**THE
NATIONAL
BOARD**
OF BOILER AND
PRESSURE VESSEL
INSPECTORS

SUBGROUP ON PRESSURE VESSELS AND PIPING

AGENDA

NB 11-2001 Part 1, 2.9.4 SG Pressure Vessels and Piping - Address the safe venting isolatable economizers where the outlet is below the inlet of other communicable chambers (Headers, drums, etc.)

Figure 1

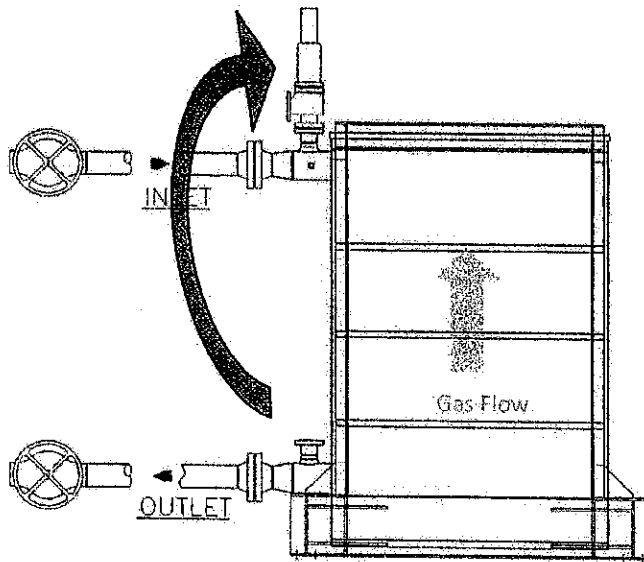
Paul Edwards		I would like to see a response to Mr. Pillow's concern.	03/26/2012
James Pillow		Jpillow 3/21/12 I disapprove because the proposal is an attempt to re-write ASME Section I rules that already address mounting of pressure relief valves. Section I does not allow the mounting of the valves "as recommended by the Manufacturer". Keep in mind that Part 1 of the NBIC does not overrule the Section I rules.	03/21/2012
Donald Patten		Mr. Richardson, I queried Mr. Olson at Victory Energy and below is his comments: Locating the PSV at the outlet without specifying an outlet location does not support an idea that the outlet of an isolated economizer is the strategic location for the PSV. The commenter is correct that, when the economizer is isolated, rarified fluid will immediately begin to collect at the upper areas. Due to the fact that the PSV can be set very close to operating pressures, the time element may not always come into effect. Anyway we look at it, allowing or the PSV location to be determined by the Designer is most beneficial. Regards, David Olson	03/21/2012

John Richardson		I approve this ballot with some hesitation. During normal operation the cooler, more dense fluid if water or wet steam would be entering the top of the exchanger. The valve is apparently sized for steam but is the slower discharge rate advisable ?? When isolation occurs a sudden transient would follow in which the more rarified fluid would collect at the top. Is it possible that the original requirement to place the PRV at or near the outlet was due to the time element?? How rapid is the pressure rise in the heat	03/07/2012

An example would be a vertical counterflow economizer where the inlet header is located above the outlet (as in Figure 1) If the designer can specify where the PSV be located then the PSV may be placed such that the release of energy, via steam, happens more slowly through the same size PSV.

Figure 1 illustrates a counter-flow economizer, in a vertical up gas path, having horizontal headers, with the outlet header below the inlet. When this type of economizer is isolated during operation, and the PSV is tripped, steam will begin to collect in the upper "inlet" header. This design allows a more controlled venting of isolatable economizers by venting steam instead of hot water. Figure 1 also illustrates moving the safety relief valve from the outlet to the preferred location.

An economizer that may not be isolated from a boiler does not require a safety relief valve. Economizers that may be isolated from a boiler or other heat transfer device, allowing the economizer to become a fired pressure vessel, shall have a minimum of one safety relief valve. Discharge capacity, rated in lbs/hr (kg/hr), of the safety relief valve or valves shall be calculated from the maximum expected heat absorption rate in Btu/hr (Joules/hr) of the economizer, and will be determined from manufacturer data, divided by 1000. The safety relief valve shall be installed in a location recommended by the manufacturer, when no recommendation exists the location shall be as close as practical possible to the economizer outlet.
